BID Addendum No. Four (4)

Iona Preparatory School

Addition and Alterations to the Pail Verni Fine Arts Center

ADDENDUM NO. Four (4) Initiation Date: June 22, 2021

MATERIALS PLAN

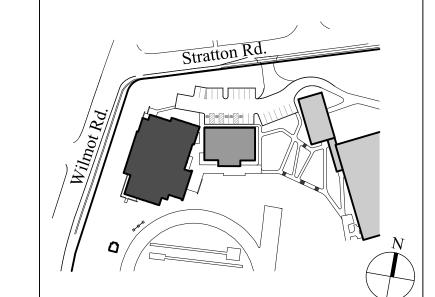
- 1. Sheet L-200 this sheet is being re-issued with location of three (3) condenser units at Verni Center.
- 2. Sheet A-101 see sketch SKA-01 for clarification to window tags at room 125.

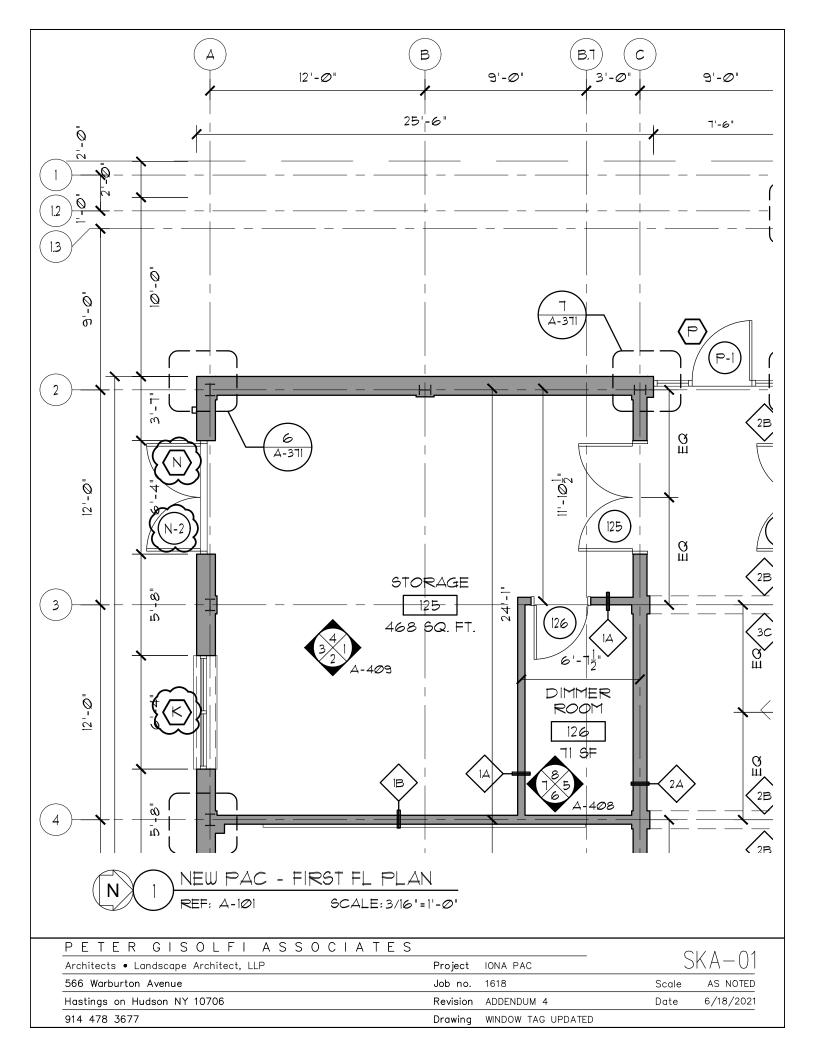
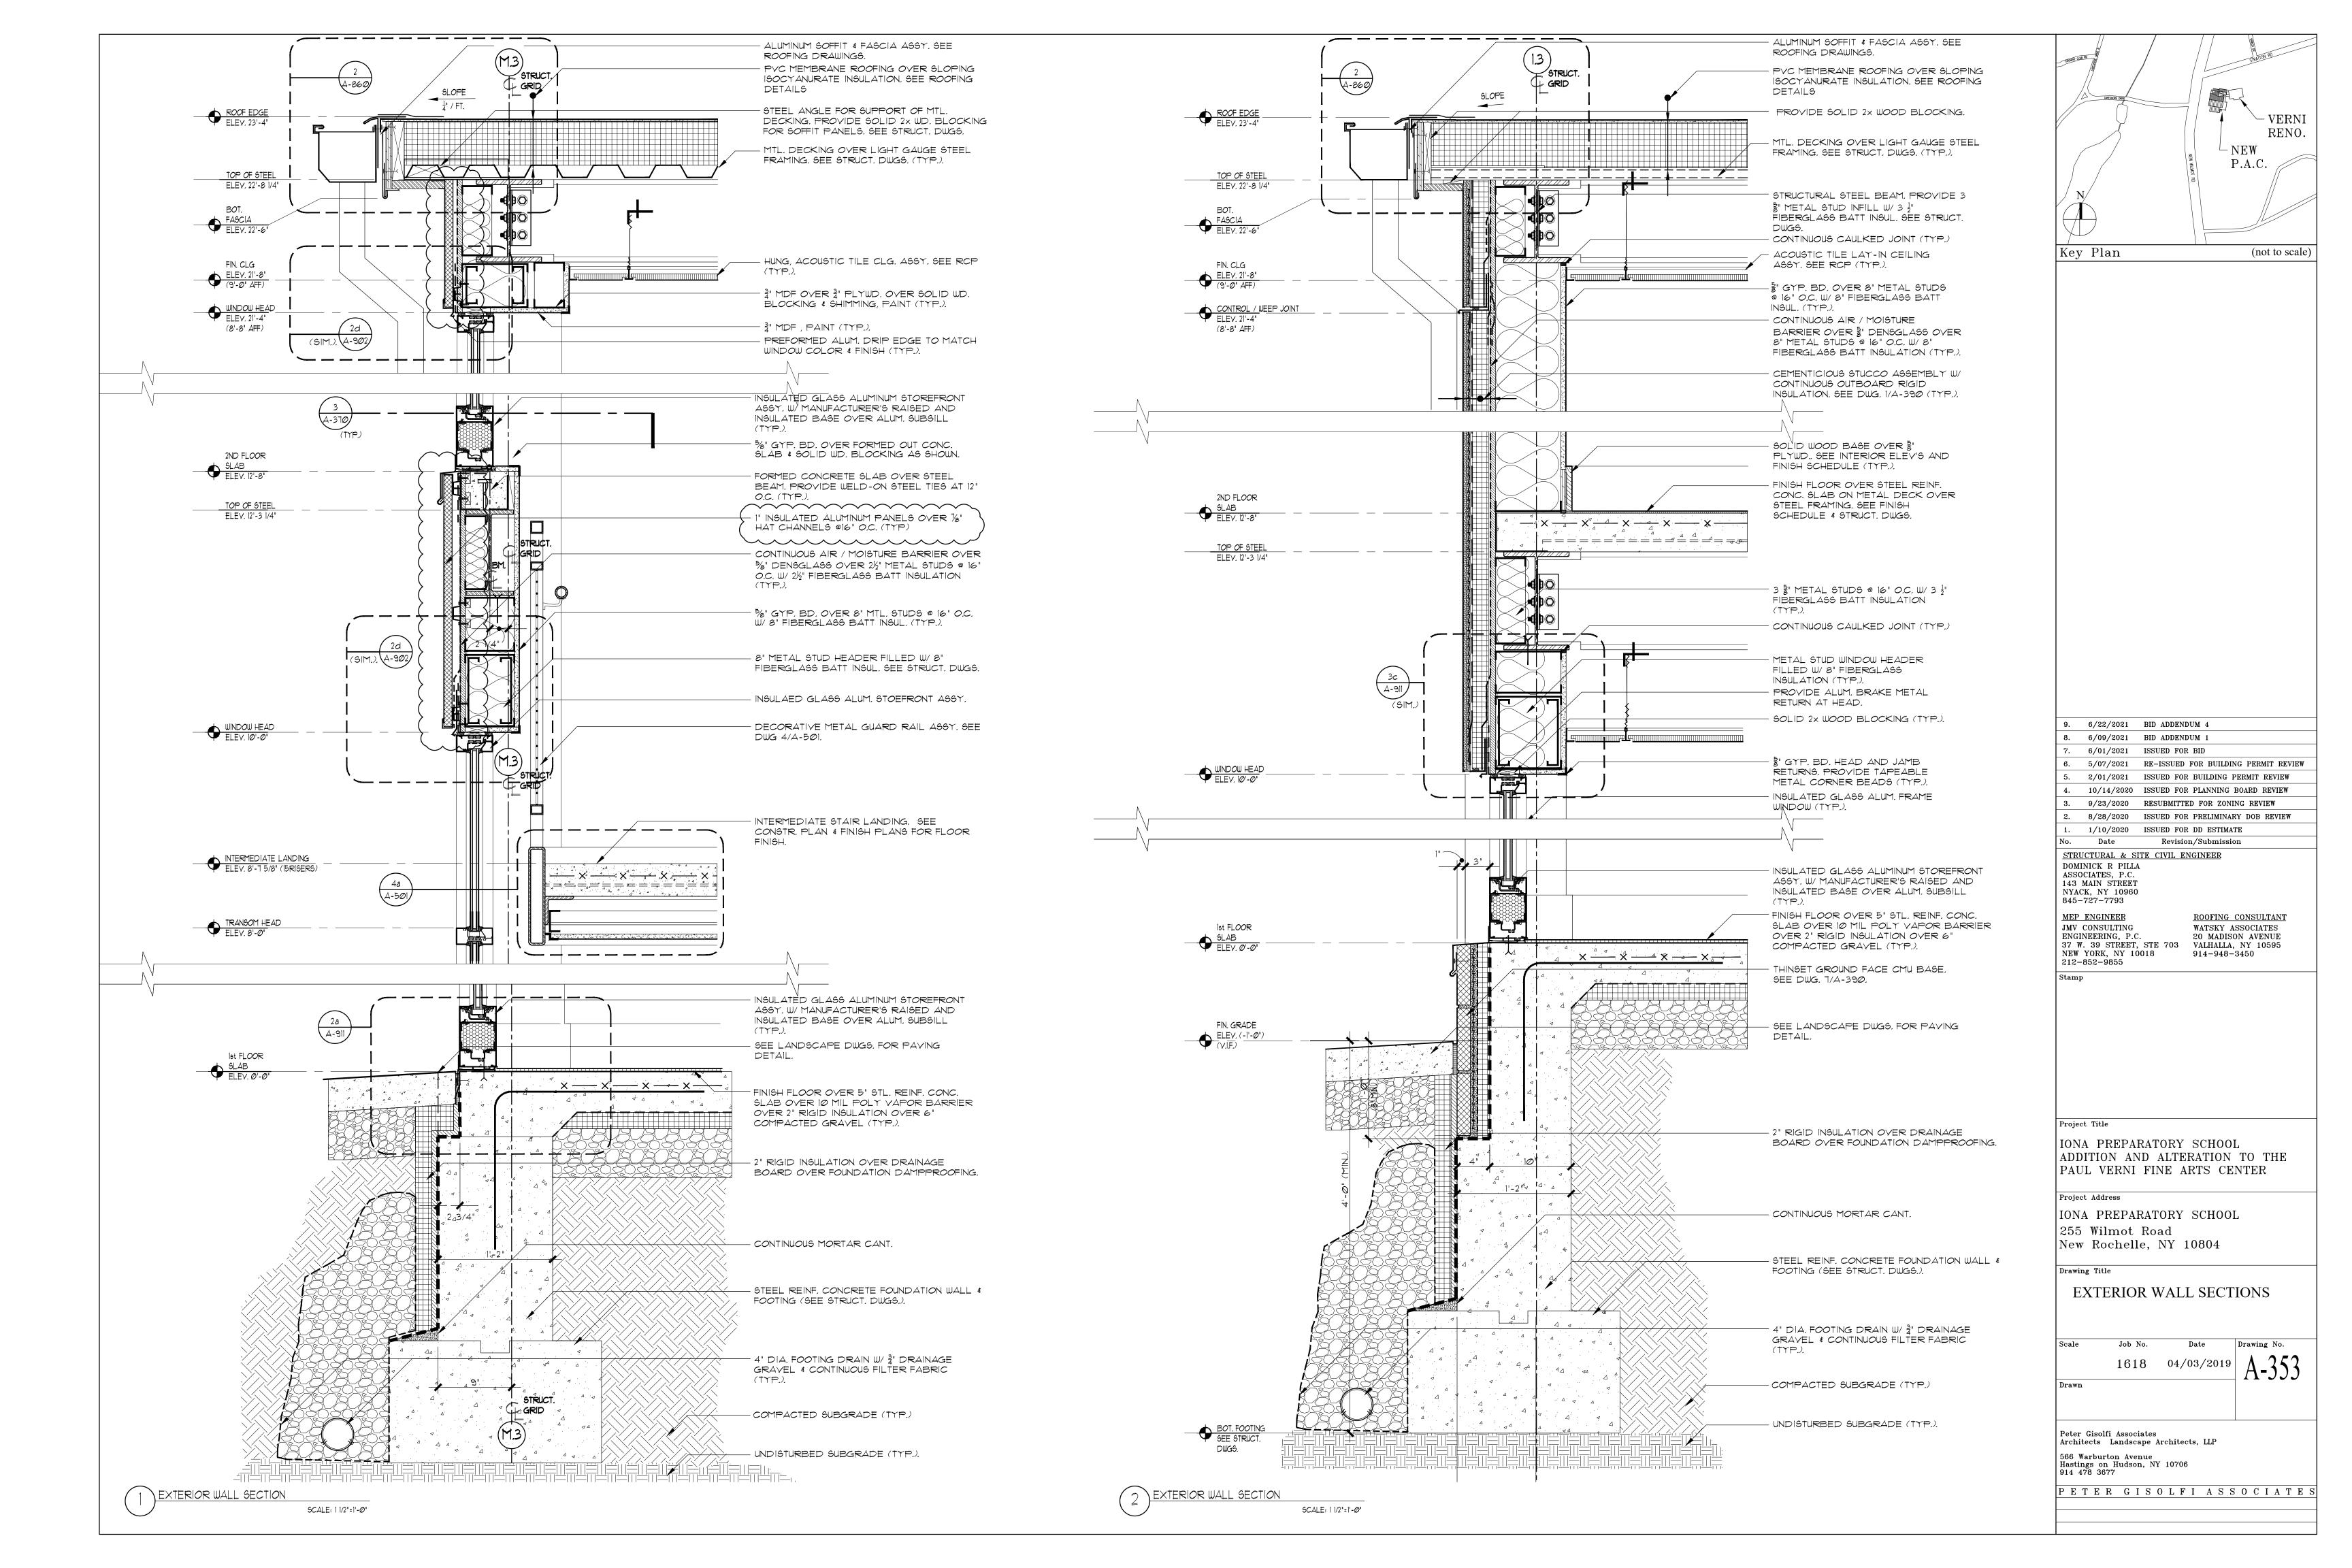
- 3. Sheet A-105a note the exterior light fixtures on the Verni building are part of the base bid and not to be excluded in Deduct Alternate #1.
- 4. Sheet A-353 this sheet is being re-issued with clarification on the exterior façade finish at stair B.
